**STAFF REPORT
KETCHUM PLANNING AND ZONING COMMISSION
MEETING OF JULY 16, 2026**

PROJECT:	Greyhawk Townhomes
FILE NUMBER:	P26-008
APPLICATION TYPE:	Preapplication Mountain Overlay Design Review
PROPERTY OWNER:	Andrew Seligson & Sarah Toral
ARCHITECT:	Mike Allaire, AIA, Michael Doty Associates Architects
REQUEST:	Preapplication Mountain Overlay Design Review for the construction of two three-story duplex buildings and associated site improvements
LOCATION:	Tax Lot 6866 (RPK4N170140730), on the north side of Warm Springs Road at the western edge of the Ketchum city limits
ZONING:	General Residential Low Density (GR-L)
OVERLAY:	Mountain Overlay and Avalanche Overlay Districts
REVIEWER:	Abby Rivin – Senior Planner
NOTICE:	A public hearing notice was mailed to all property owners within 300 feet of the project site on June 24, 2026. The notice was published in the Idaho Mountain Express on June 24, 2026. A notice was posted on the city's website on July 1, 2026 and on the project site on July 9, 2026.

BUILDING A - EXTERIOR ELEVATIONS

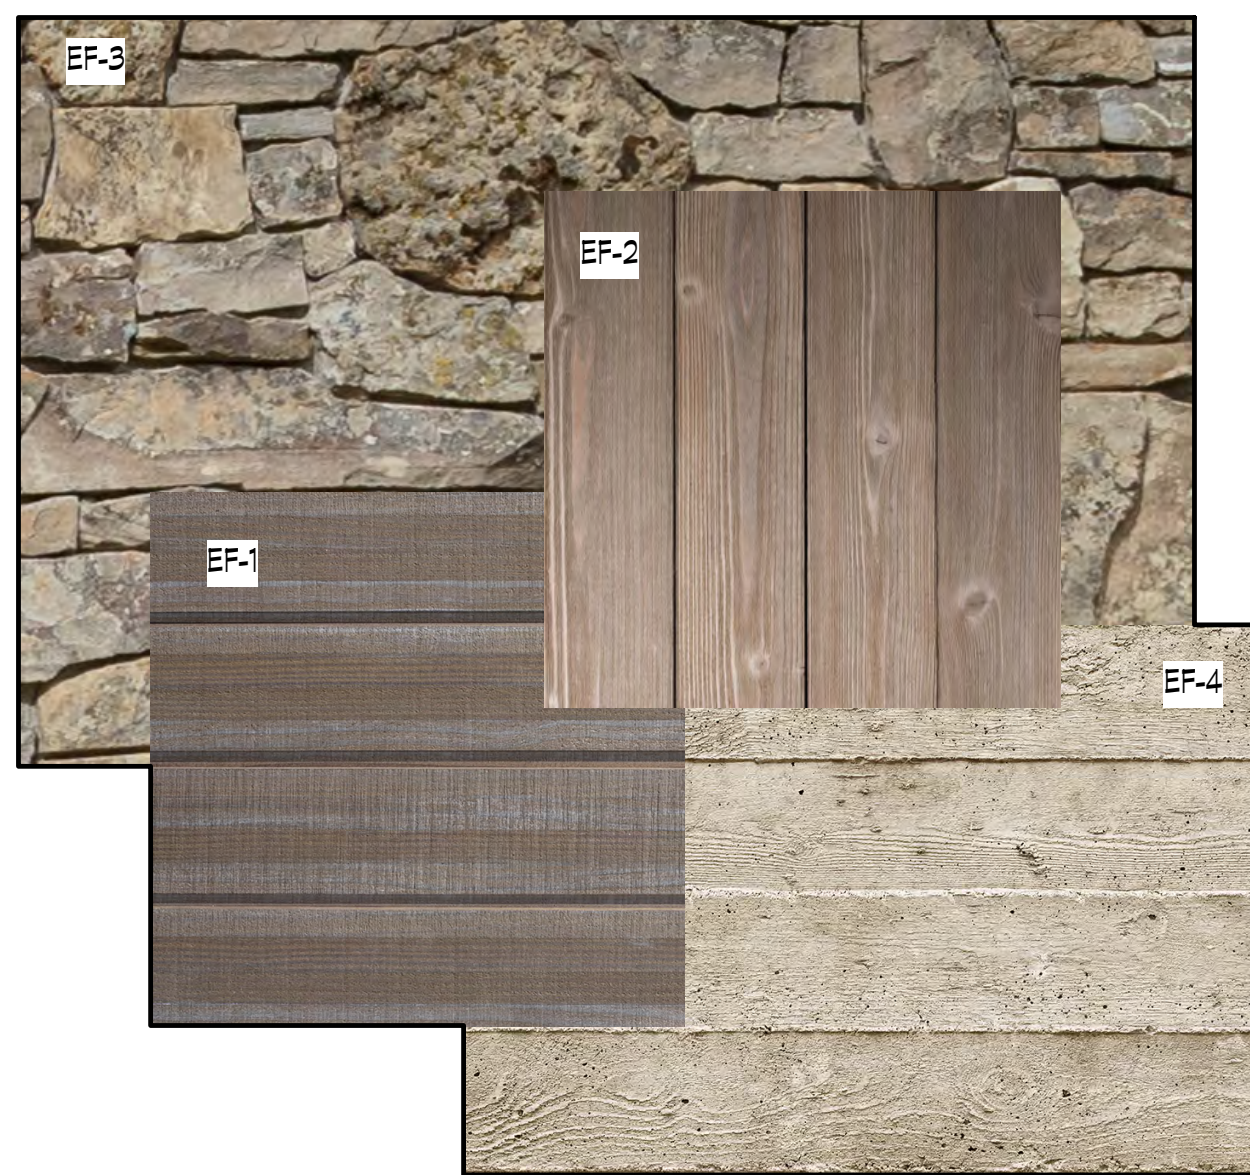
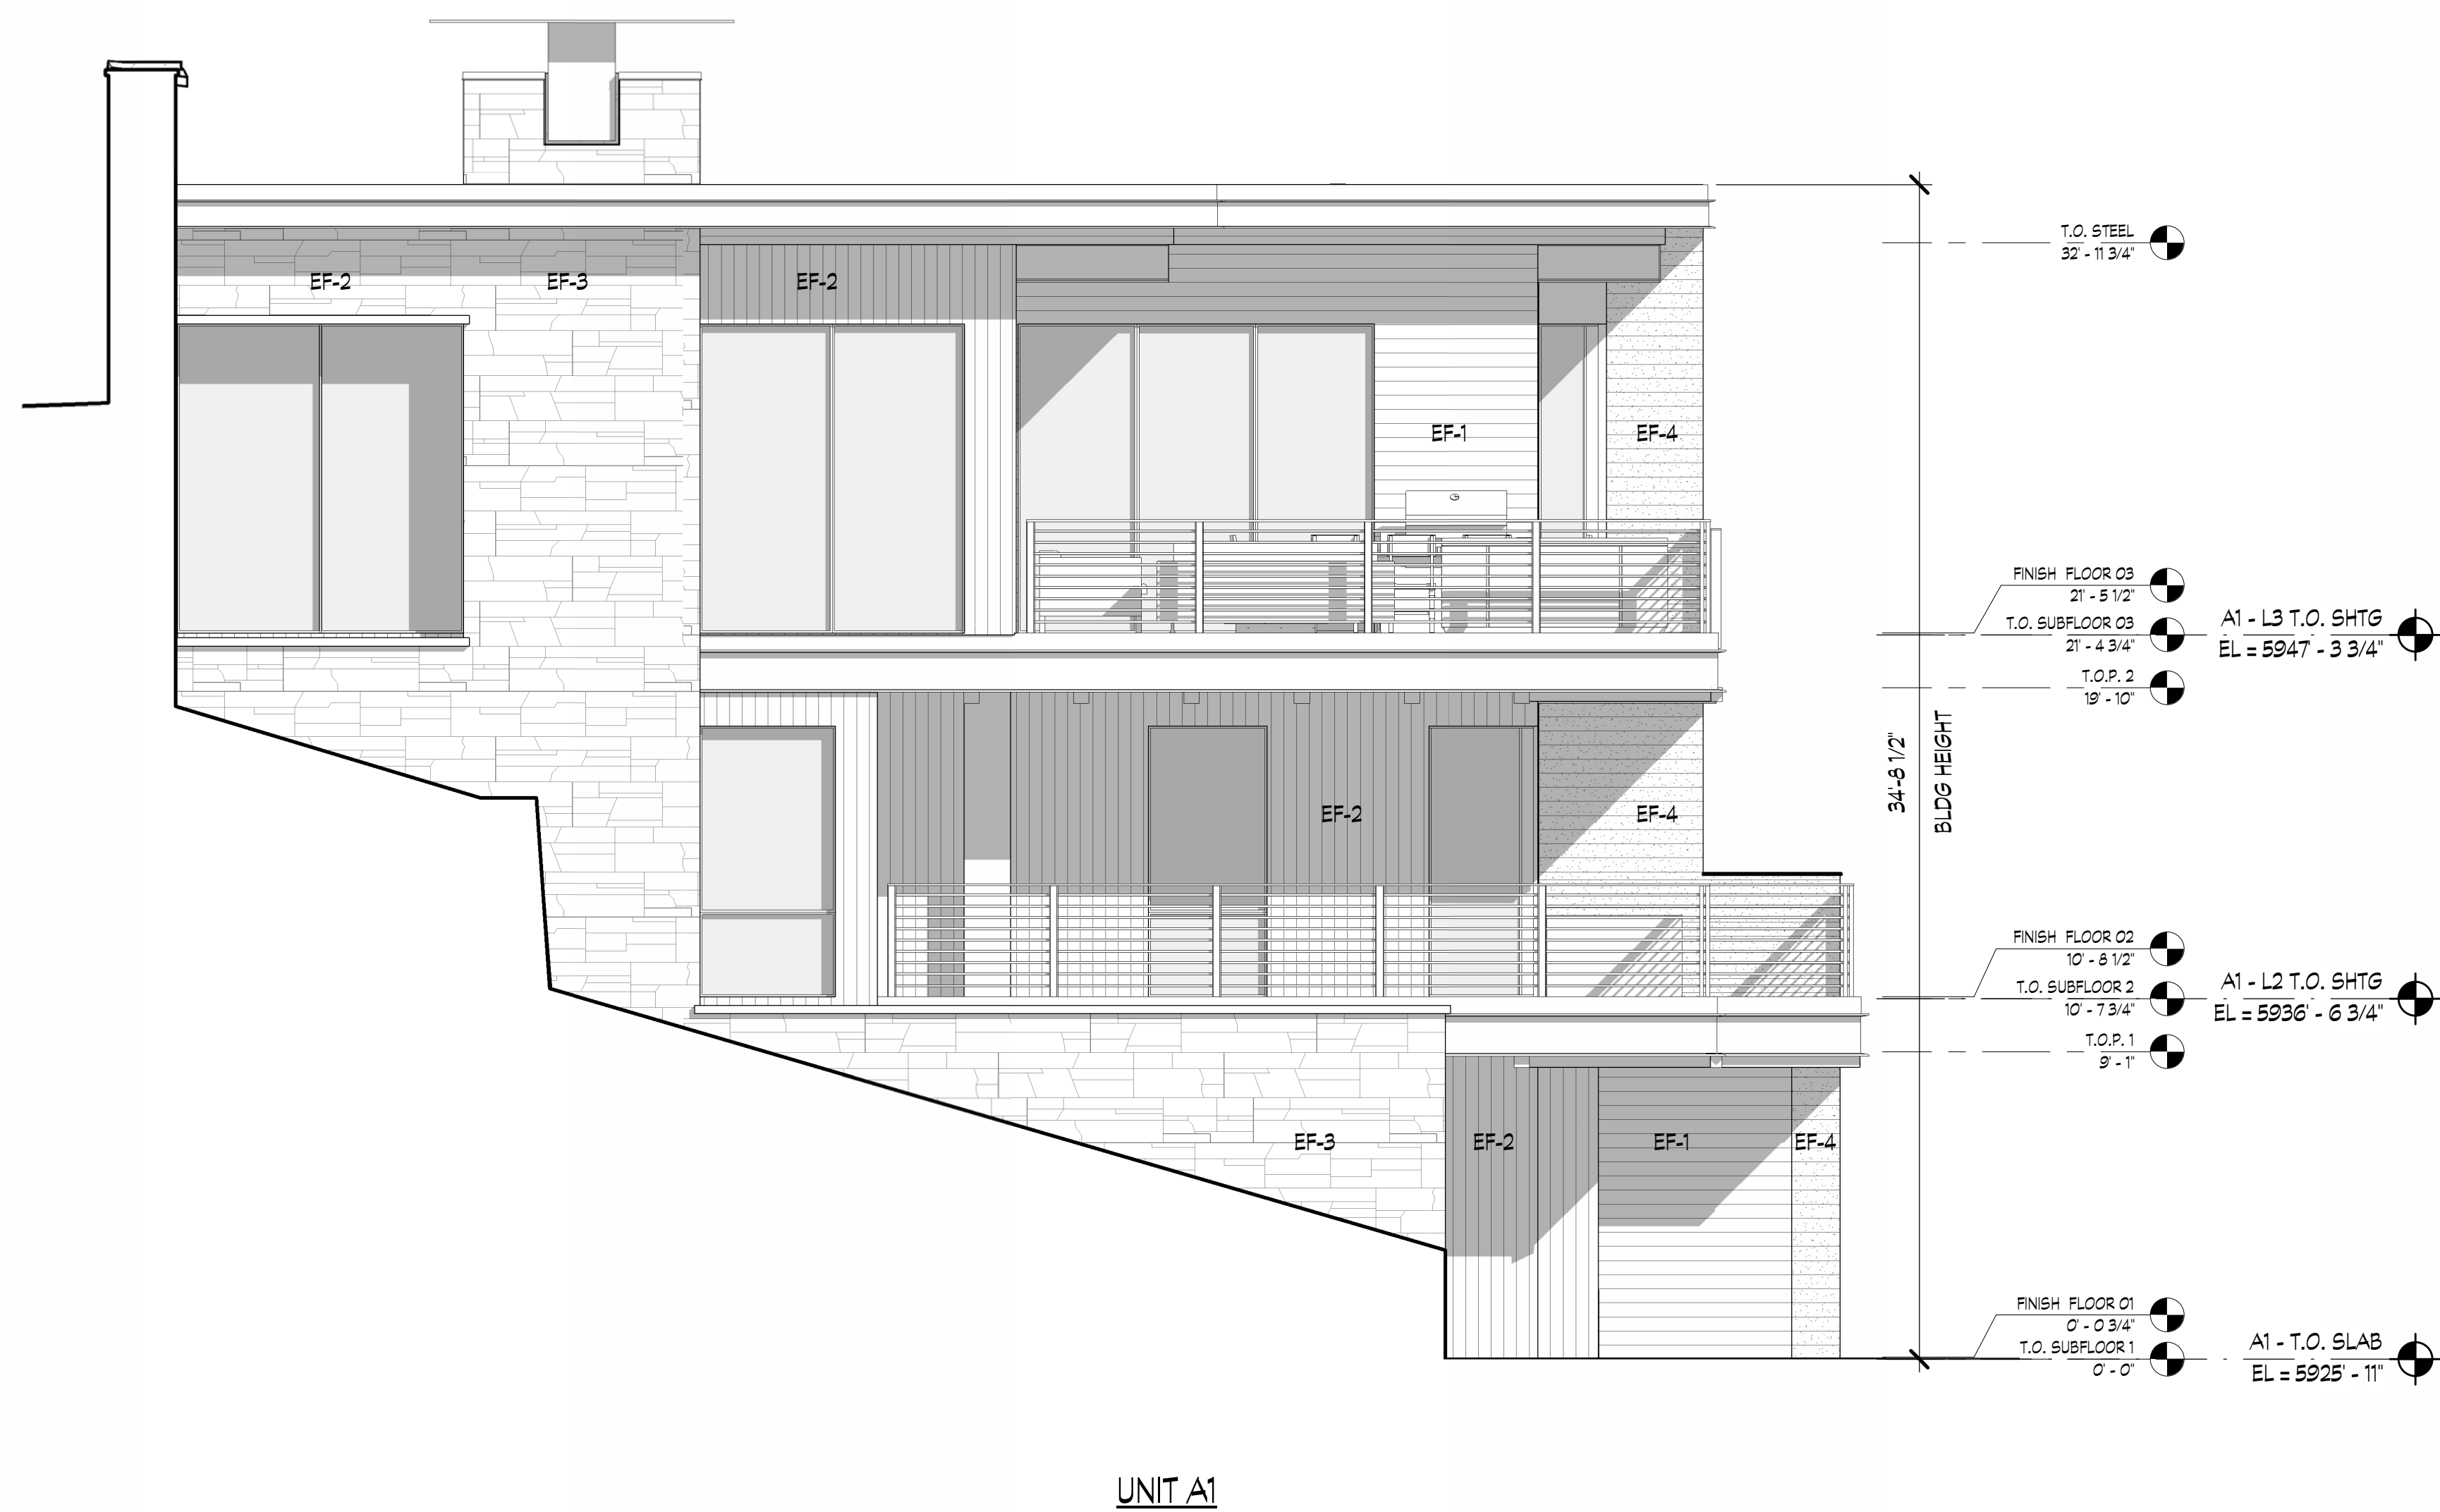
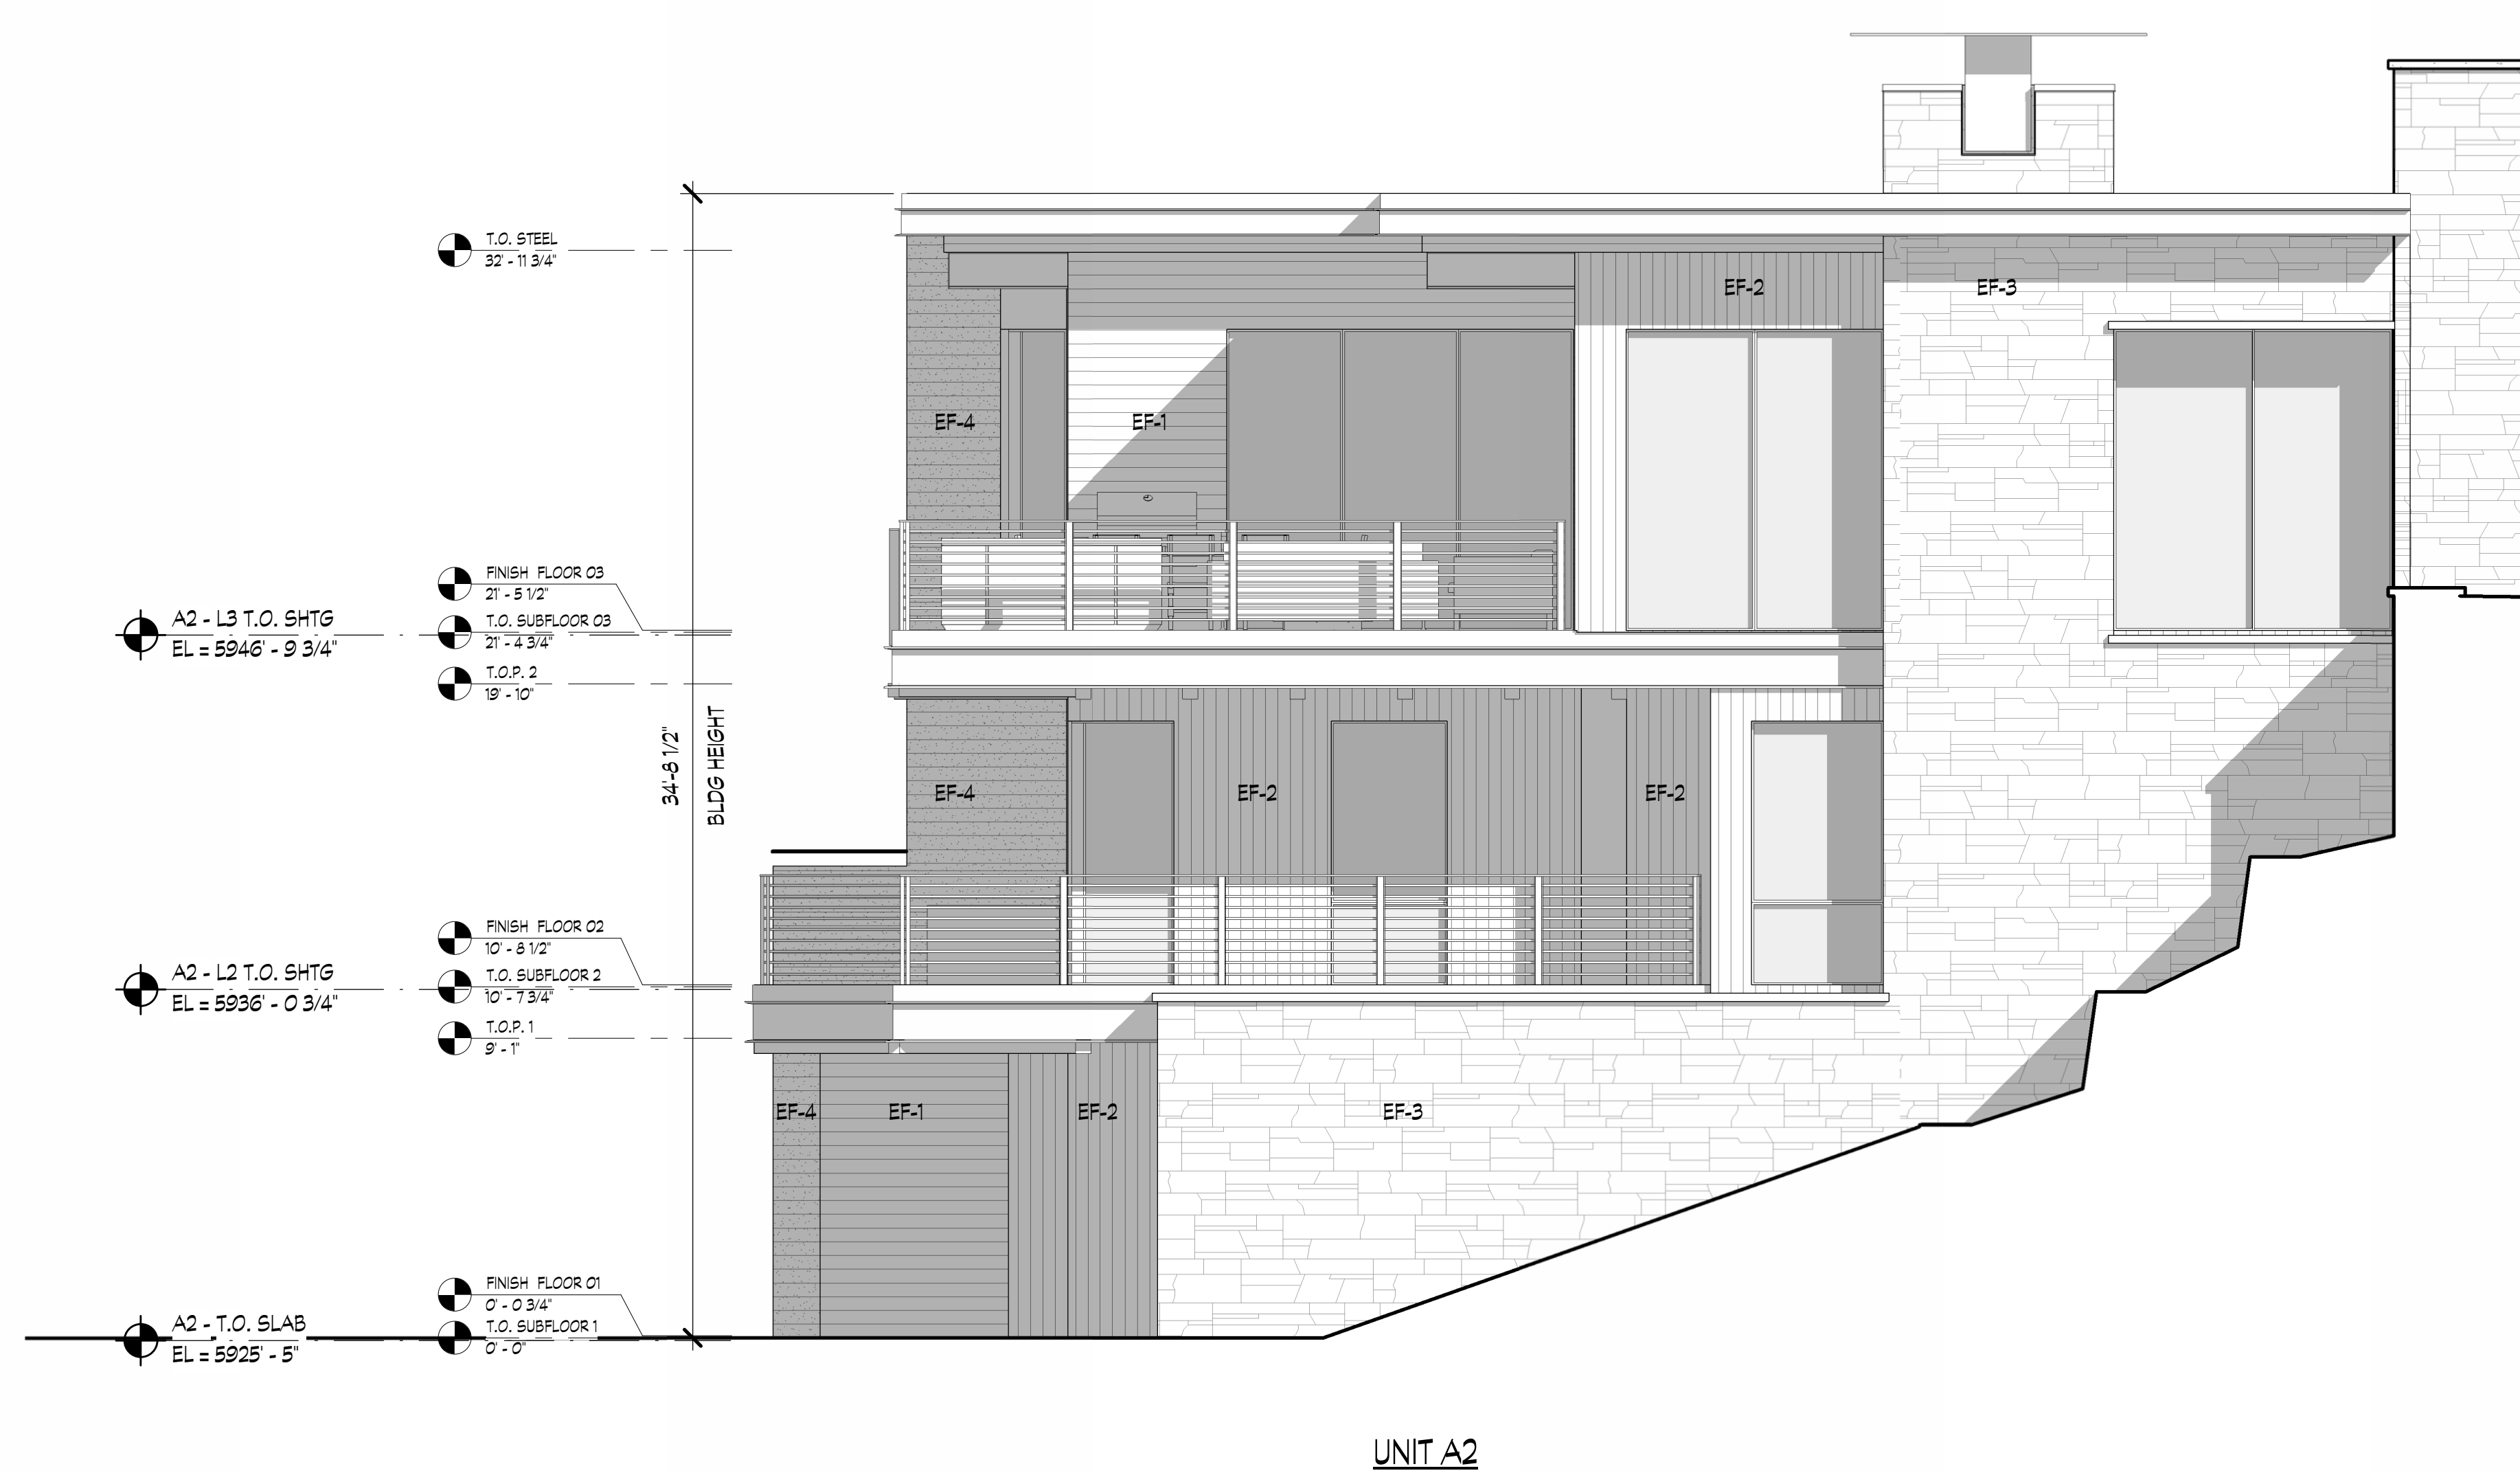
The submitted building elevations (Sheets A-312 and A-322) indicate that building height has been measured to the top of the flat roof. However, pursuant to the definition of Building Height in LDC §16.08.020, building height must be measured from the lowest of natural, existing, or finished grade to the highest point of the structure, including parapets and other roof elements. Based on the submitted plans, staff cannot verify compliance because the rear avalanche protective wall appears to be the highest point of the structure but is not included in the building height calculation. Prior to final Mountain Overlay Design Review, the applicant should revise the building height calculations to measure to the highest point of each structure in accordance with LDC §16.08.020.
